ADDENDUM

TSBC Building

Roof Replacement and Wood Truss Reinforcing

AD-1

S-101

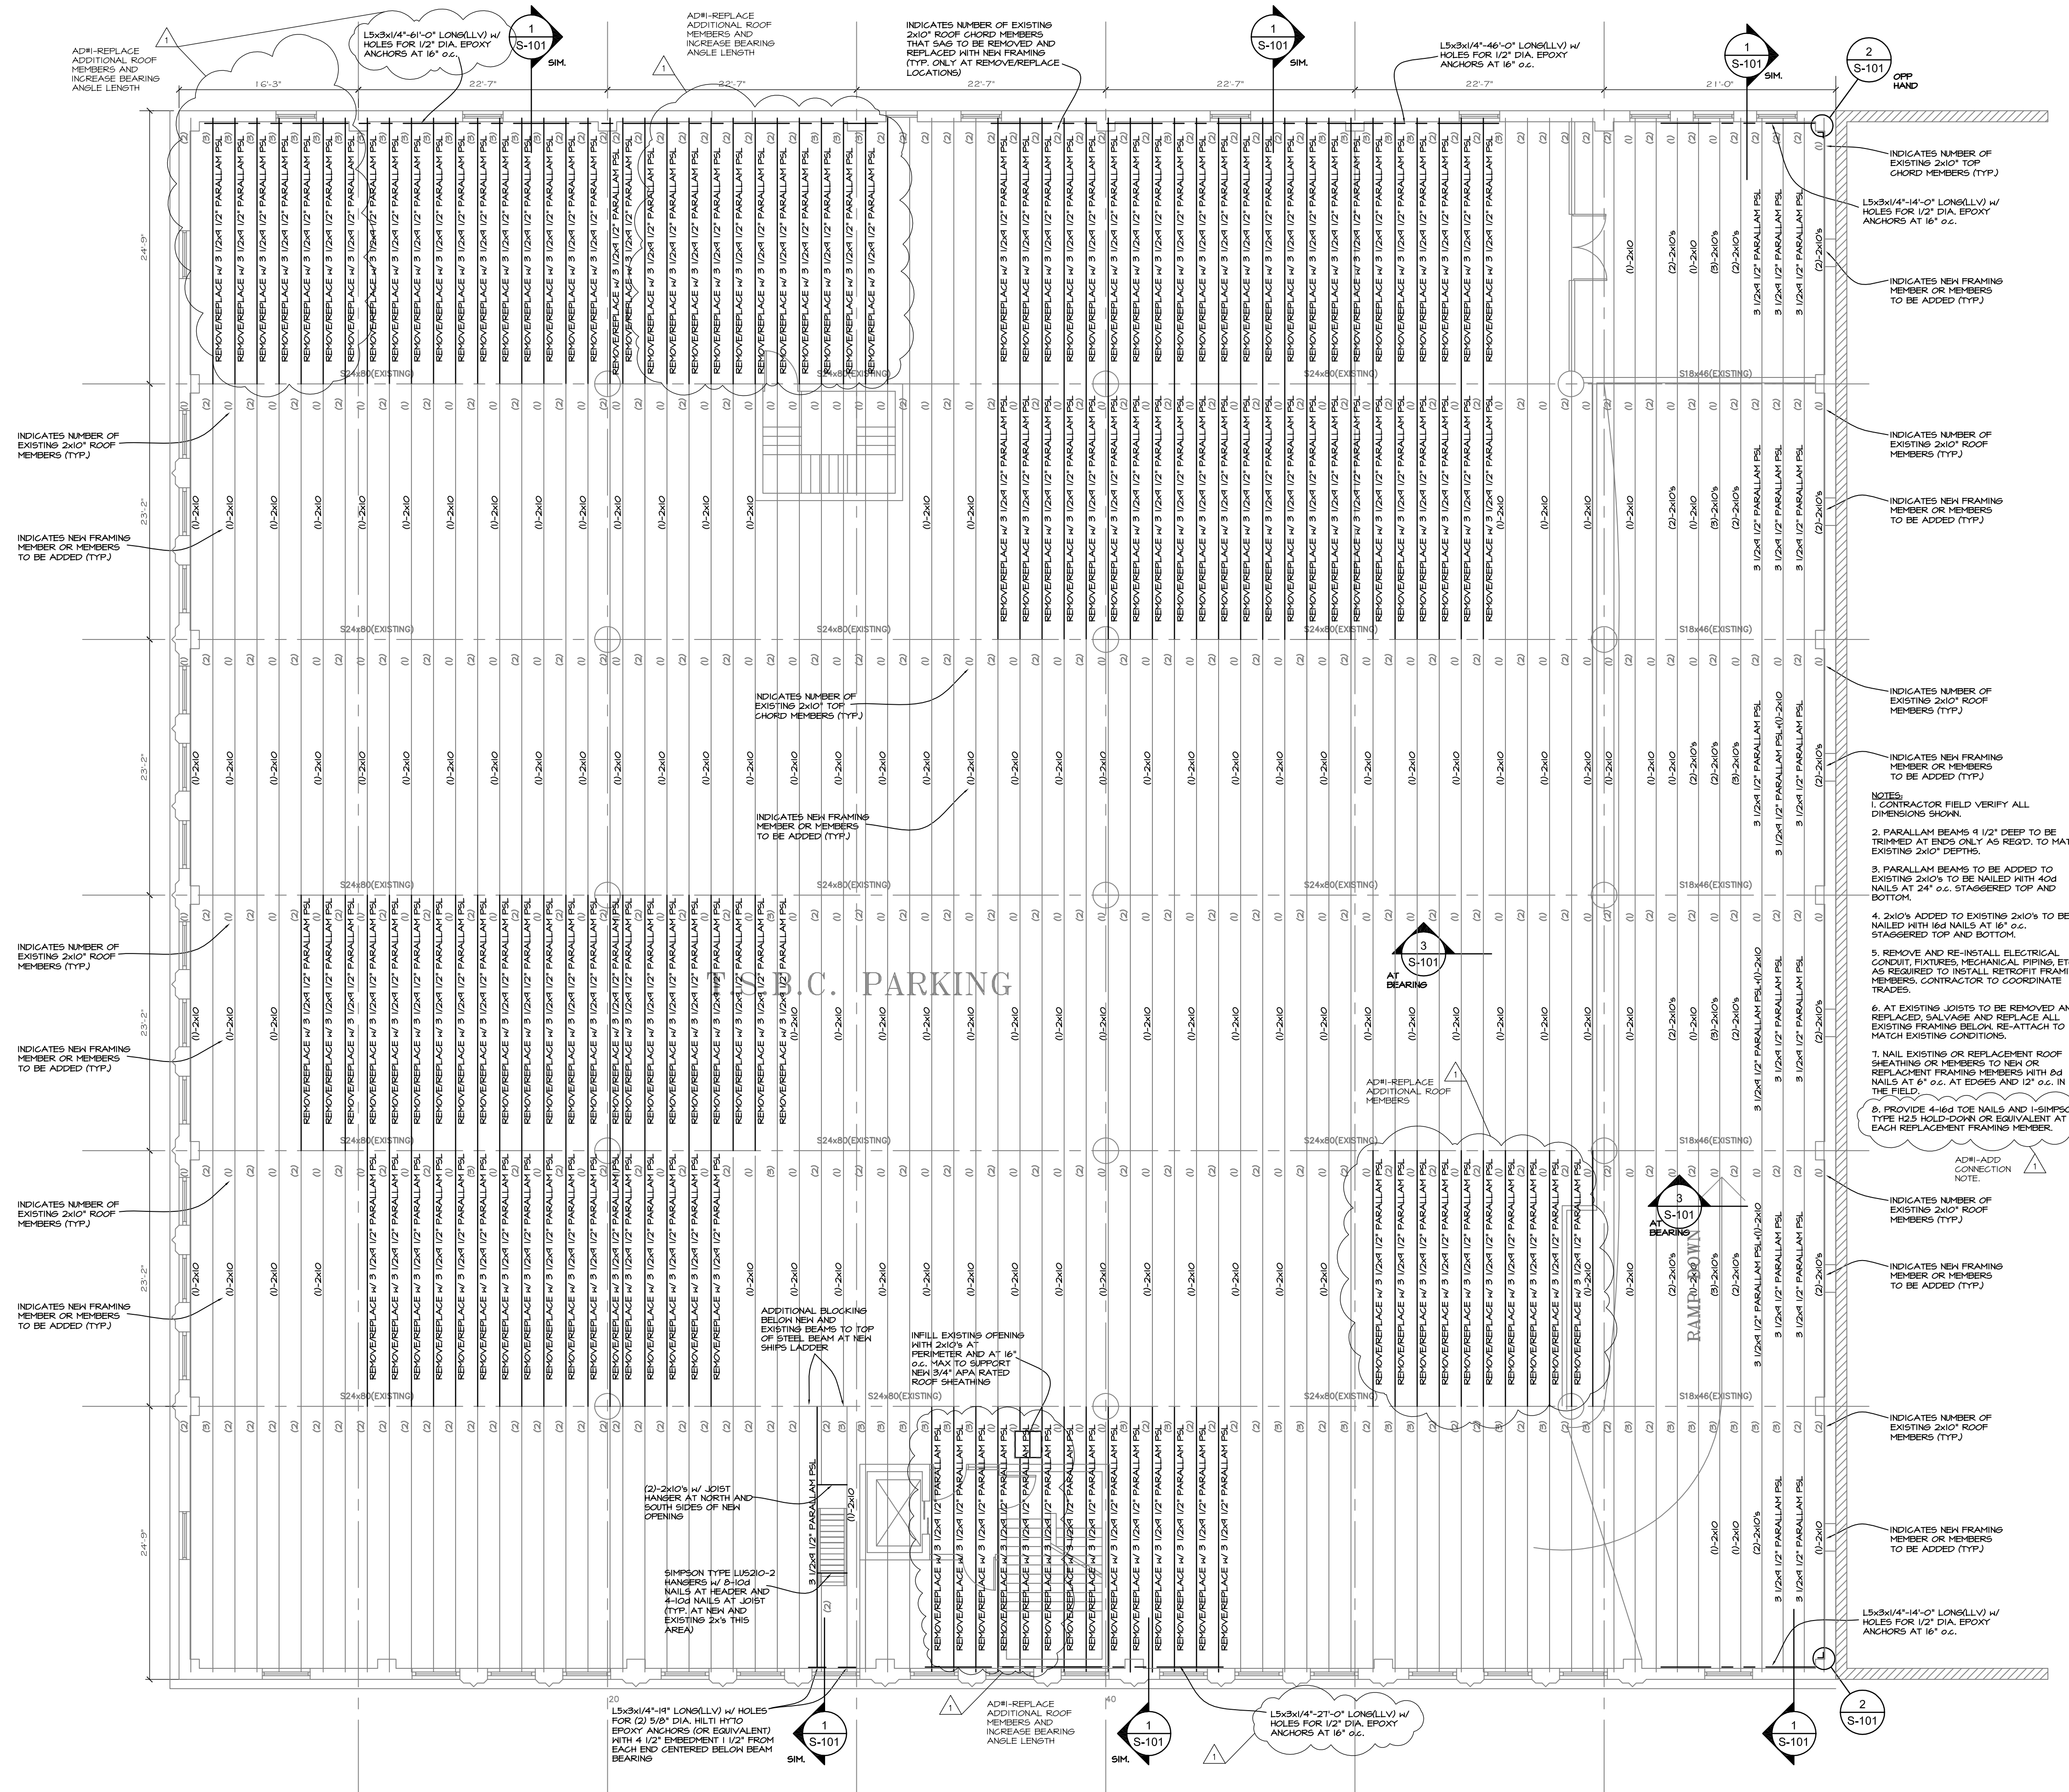
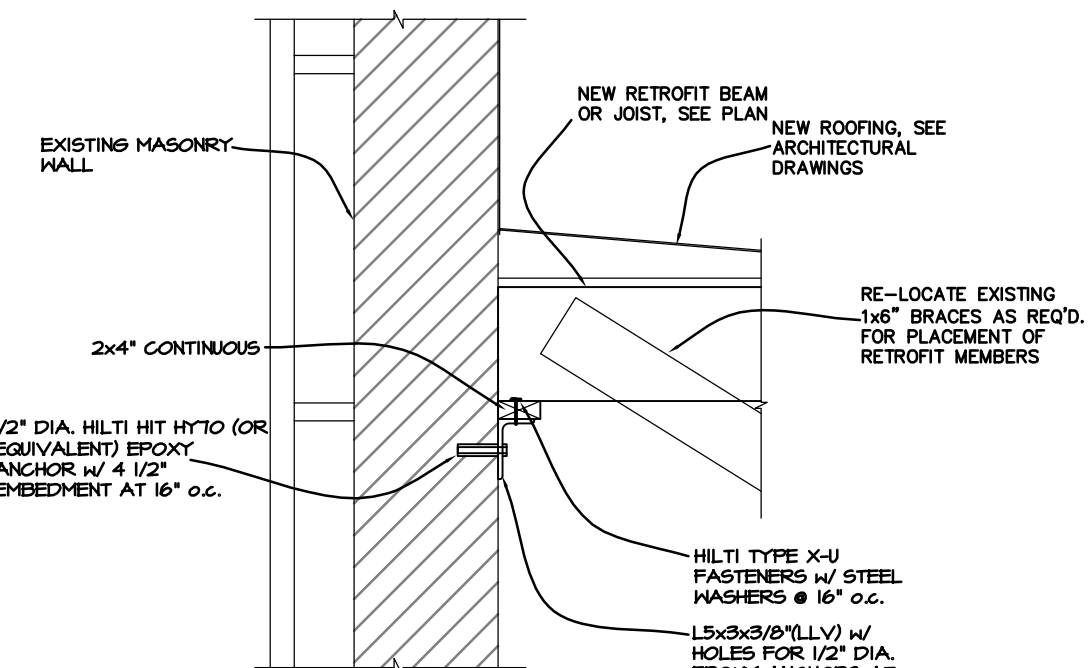
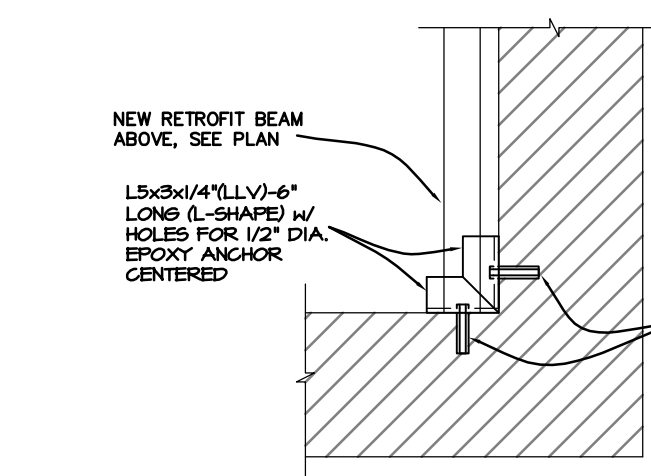
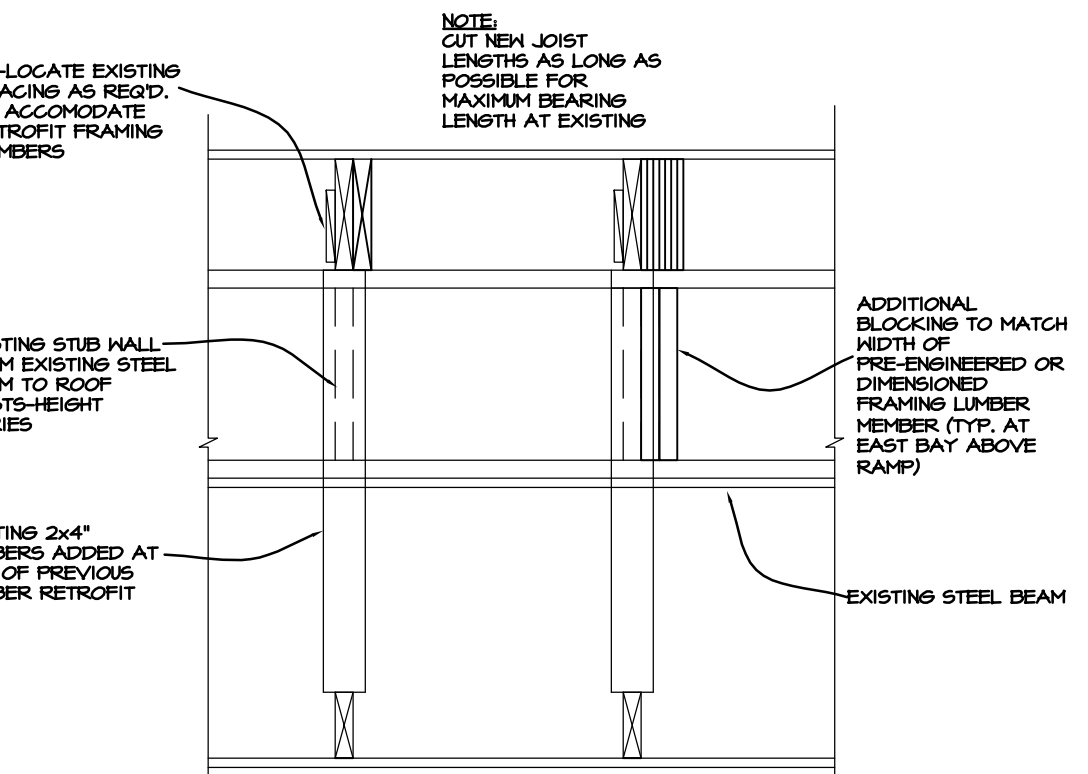
In reference to Sheet S-101, replace Sheet S-101 with attached full-size revised Sheet S-101. Provide additional locations for remove and replacement framing members and increase support angle lengths and anchors where required at exterior wall bearing. Add note number 8 indicating replacement framing attachment to existing.
